Subject: DA2022/0653 1 Bellevue Parade, North Curl Curl

Fifth objection submission

DA2022/0653 1 Bellevue Parade, North Curl Curl

4.1.4.1 Street Front setbacks

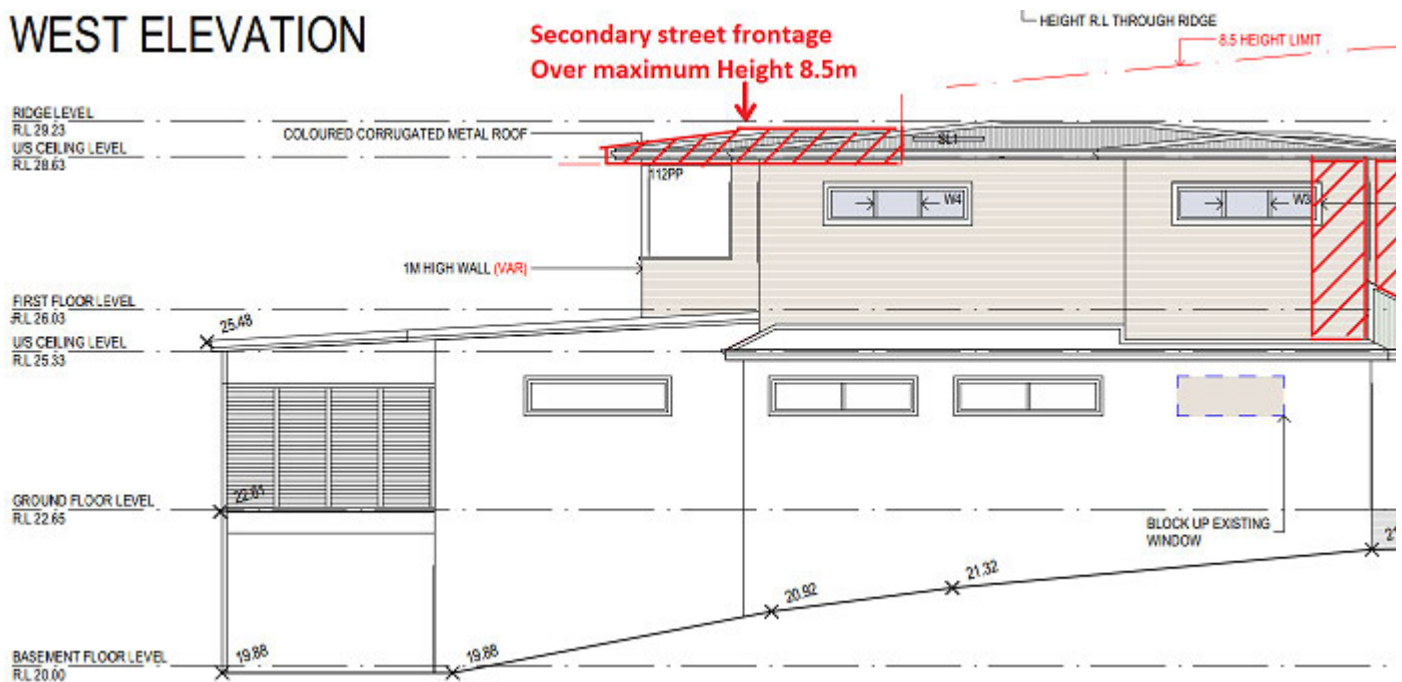
Section (b) of 4.1.4.1 Street Front Setbacks states “a minimum 6m front setback applies”. The planned addition to the existing front of the house is non-compliant, as it is in the 6m minimum front setback requirement.

Section (c) states “the street setback is to be increased for any proposed upper floor level”. All the properties in Bellevue Parade have abided by this ruling. The properties that have added an upper floor level have complied by the setback rulings by building the upper floor level back from the existing first floor.

Figure 31 - Side Setback Diagram

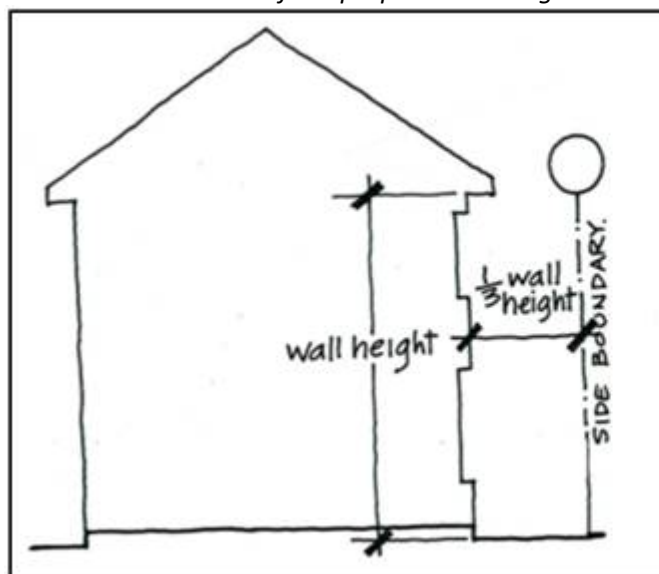
Section 4.1.4.2(a) Side Setbacks and Secondary Street Frontages states that “side boundary must not be less than one third of the height of the adjacent external wall”. Refer to Figure 31 – Side Setback Diagram above. The height of the eastern wall on the DA is 6,660mm. One third of the wall is 2,220mm. The minimum addition to the eastern side boundary has to be 2,220mm whereas the DA has it at 1050mm.

WEST ELEVATION

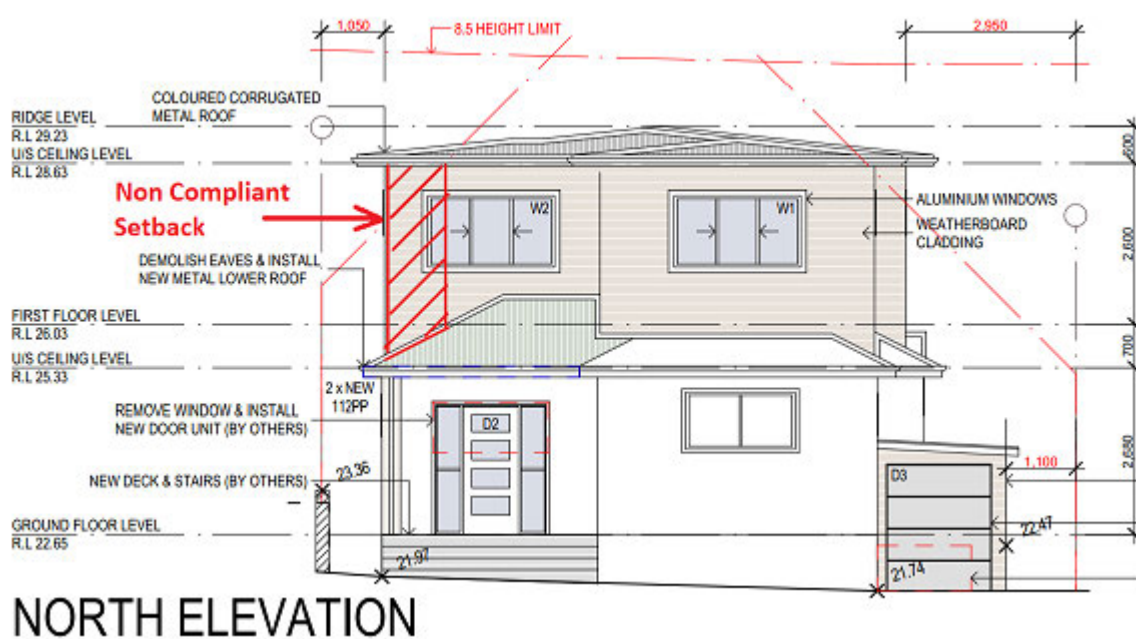
This highlights the non-compliance of the new addition with setbacks on the eastern and front boundaries in regards to the Setback rulings.

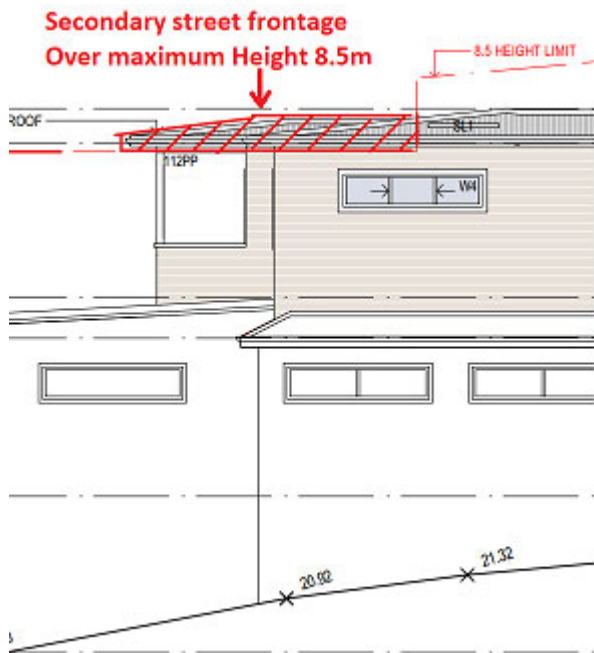
No 1 Bellevue Parade’s secondary frontage (eastern side of the house) will be visually bulky and impacting the streetscapes. The complete non-complying structure of the proposed development will be viewed from Bellevue Place. It must comply with the setback rules and height restrictions. Therefore the 8.5m maximum height limit must apply to the full roof line. The roof height of 9m, which extends more than a third of the house, does not comply with the maximum height limit of 8.5m.
